MONITORING YEAR 0 ANNUAL REPORT

BANNER FARM MITIGATION SITE

RE: **Banner Farm Draft MY0 Report Review**
French Broad River Basin – CU# 06010105
Henderson County
DMS Project ID No. 100062
Contract # 7530

Wildlands Engineering, Inc. (Wildlands) has reviewed the Division of Mitigation Services (DMS) comments from the Draft As-built Monitoring report for the Banner Farm Mitigation Site provided in bold type below and offers the following responses in italics.

2.2

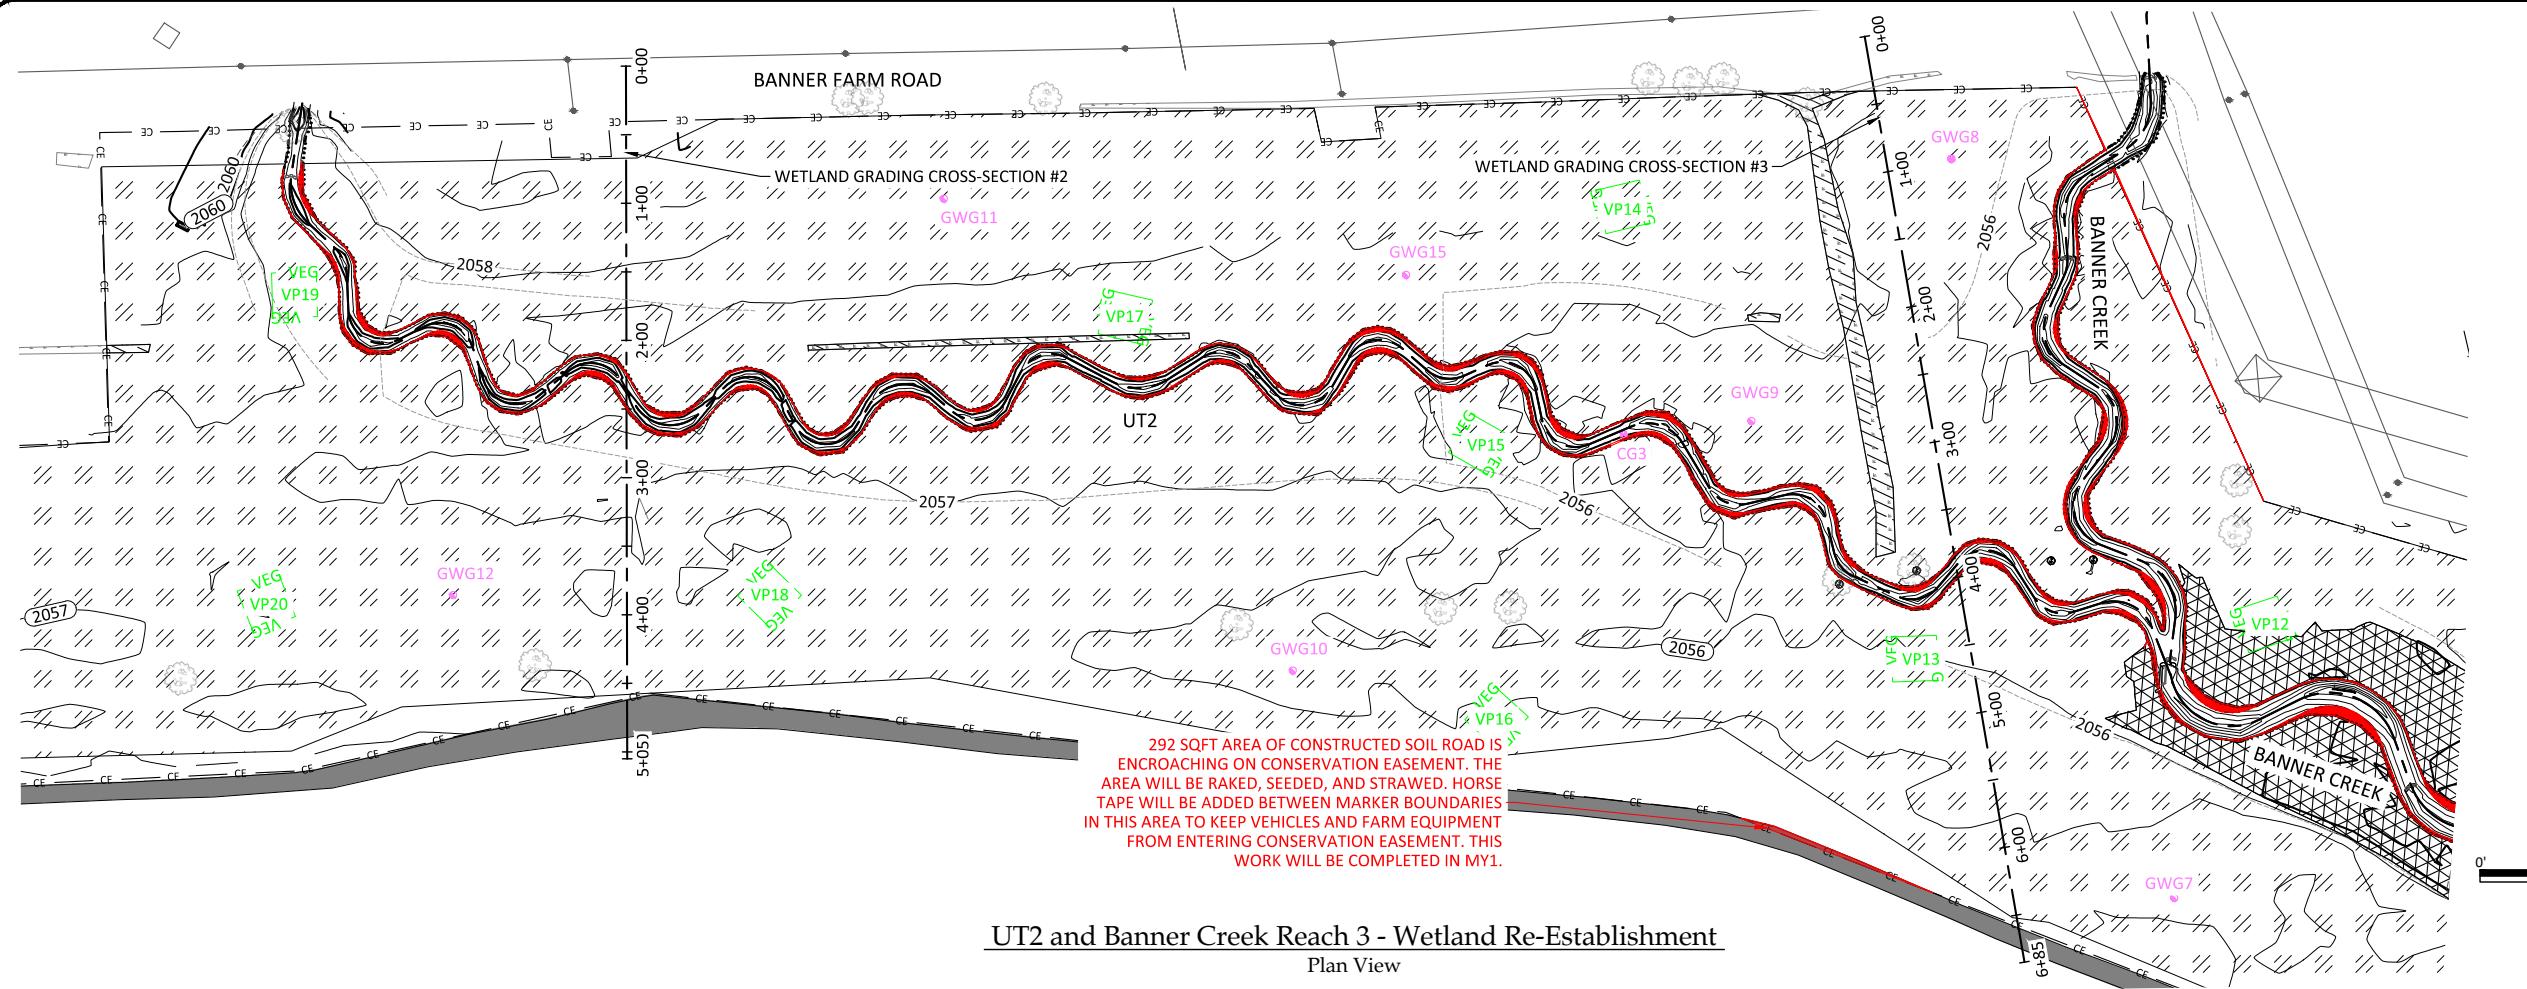
- Wetland grading sheet 2.2 – The constructed farm entrance is encroaching on the conservation easement but not on mitigation assets. During construction, the location of the farm entrance had to be modified. The entrance was proposed (and built) between two existing DOT bridges. An existing overhead electric guy wire pole and newly installed narrow bridge notification sign conflicted with the original proposed location of the farm entrance. Based on the field conditions including existing utilities, DOT signage, FEMA considerations, and landowner workability it was determined that the best course of action was to shift the entrance west, which resulted in the minor encroachment on the conservation easement. Wildlands is currently working to modify the recorded conservation easement to release the area and rectify the encroachment. The conservation easement modification will be completed in MY1.

2.4

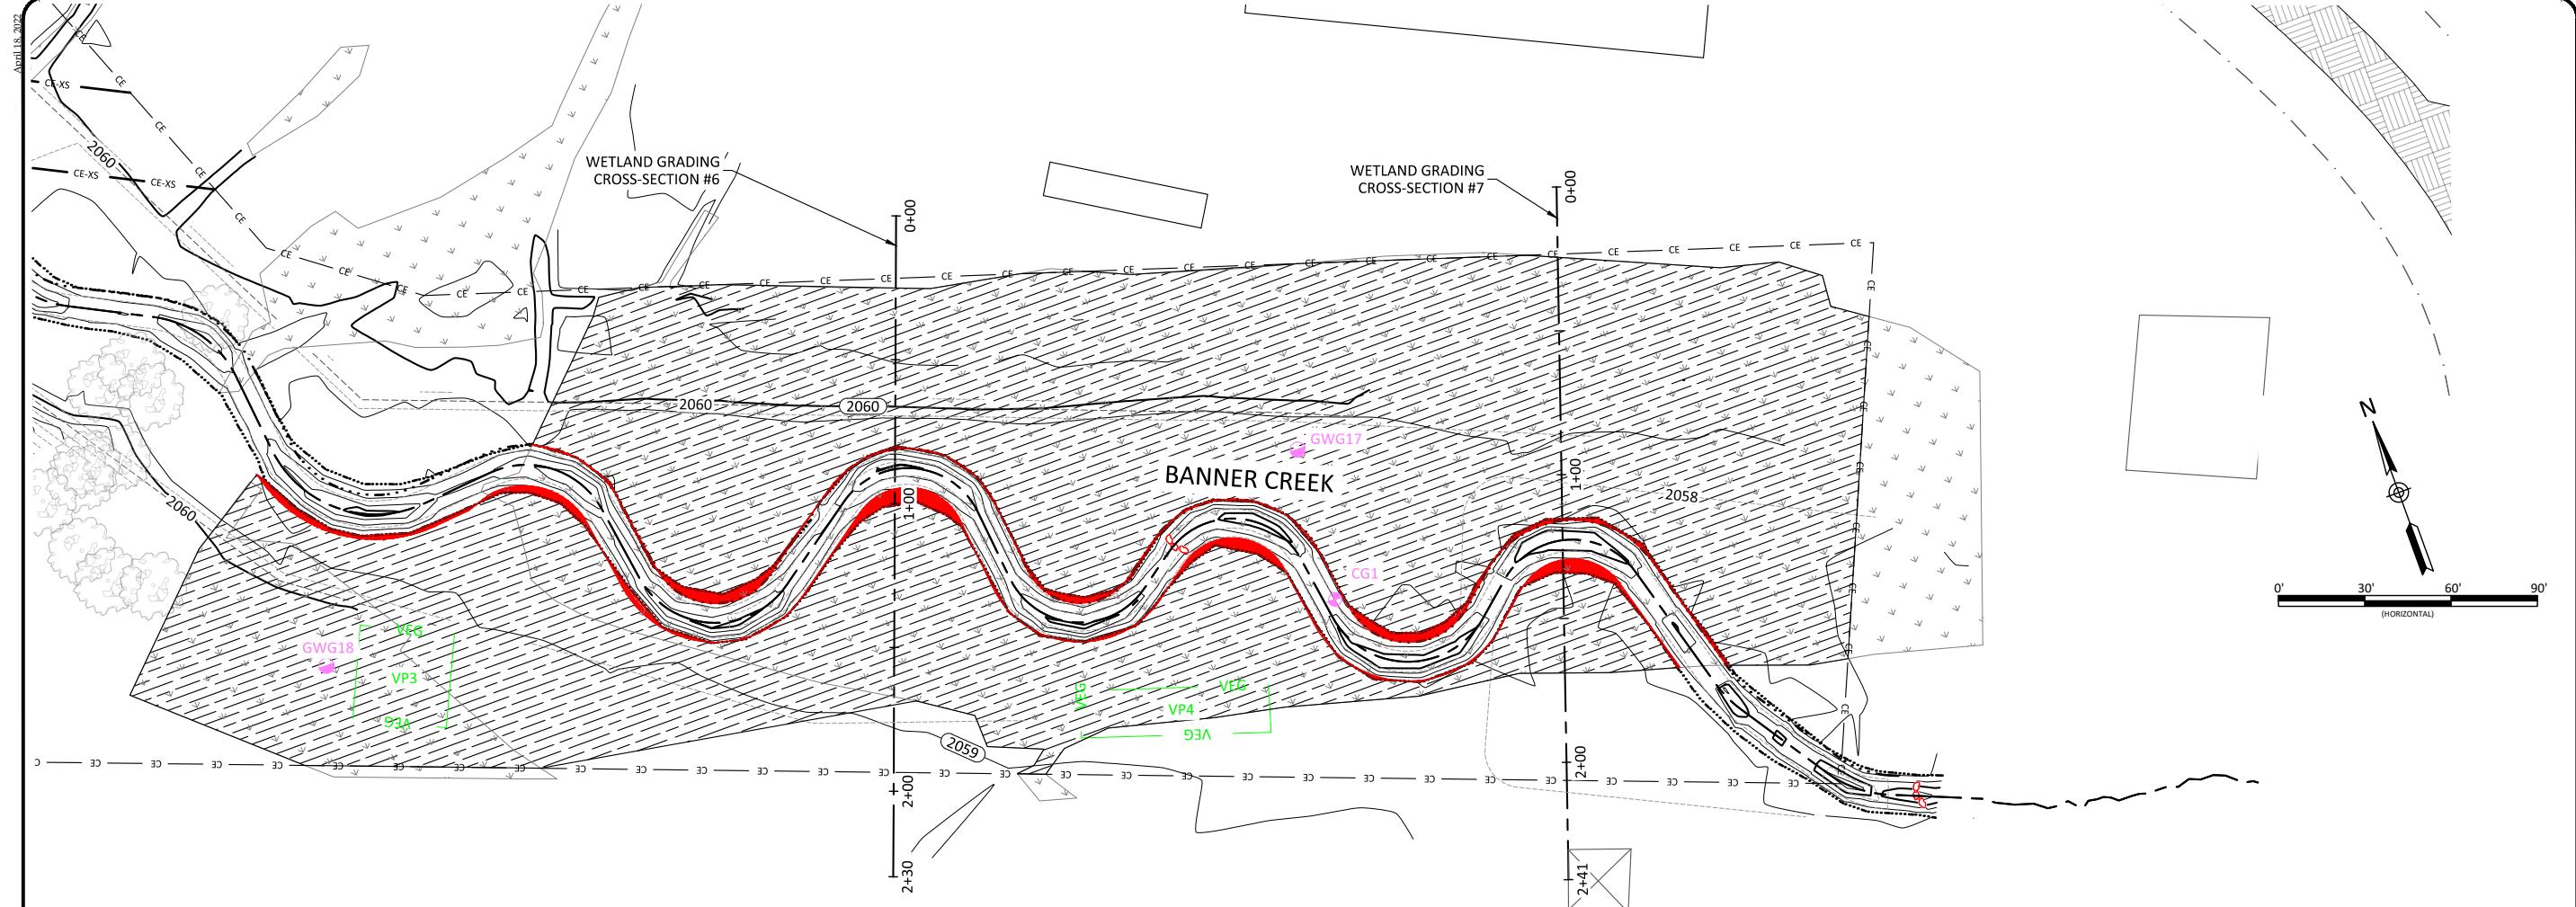
- Wetland grading sheet 2.4 – 2 SQFT of constructed soil road is encroaching on conservation easement. The area will be raked, seeded, and strawed. This work will be completed in MY1.

Sheet 3.3

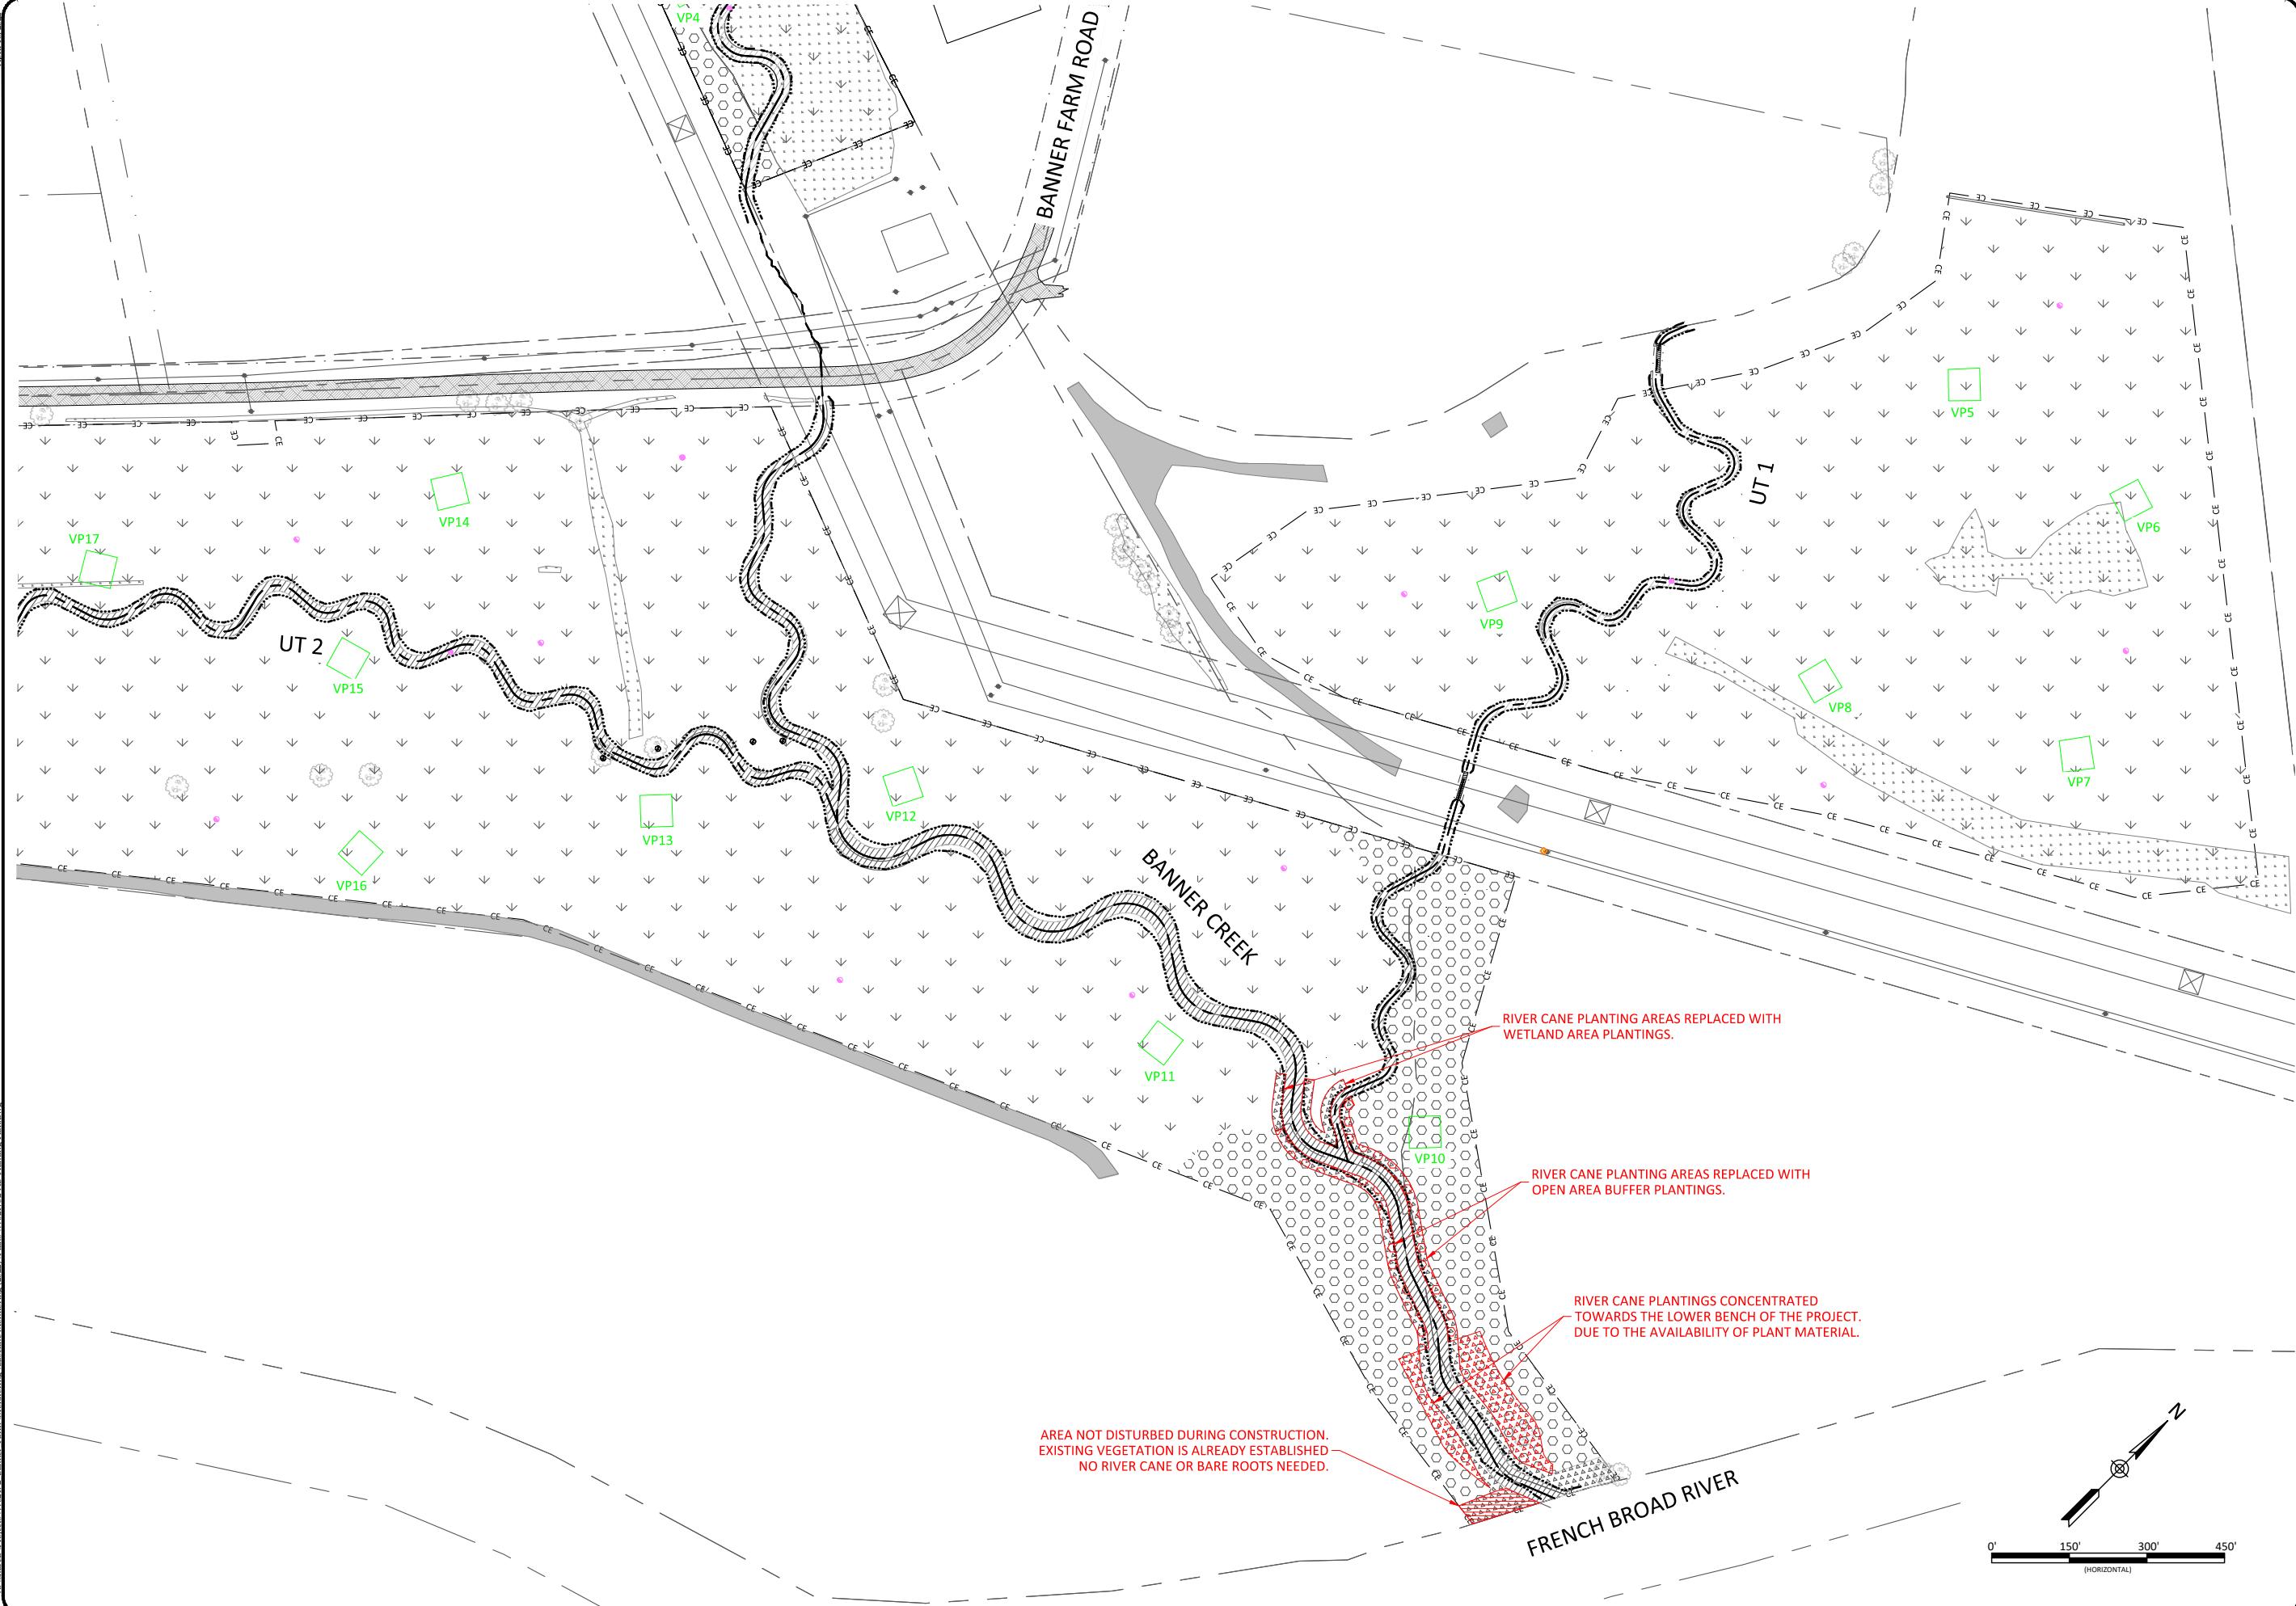
- Sheet 3.3 – No bare roots were planted due to the depth of standing water.
- Sheet 3.3 – No bare roots were planted due to farm road encroachment.
- Sheet 3.4 – River cane planting areas replaced with wetland area plantings. Due to the availability of plant material.
- Sheet 3.4 – River cane planting areas replaced with open area buffer plantings. Due to the availability of plant material.
- Sheet 3.4 – River cane plantings concentrated towards the lower bench of the project. Due to the availability of plant material.
- Sheet 3.4 – Area not disturbed during construction. Existing vegetation is already established. No river cane or bare roots needed.
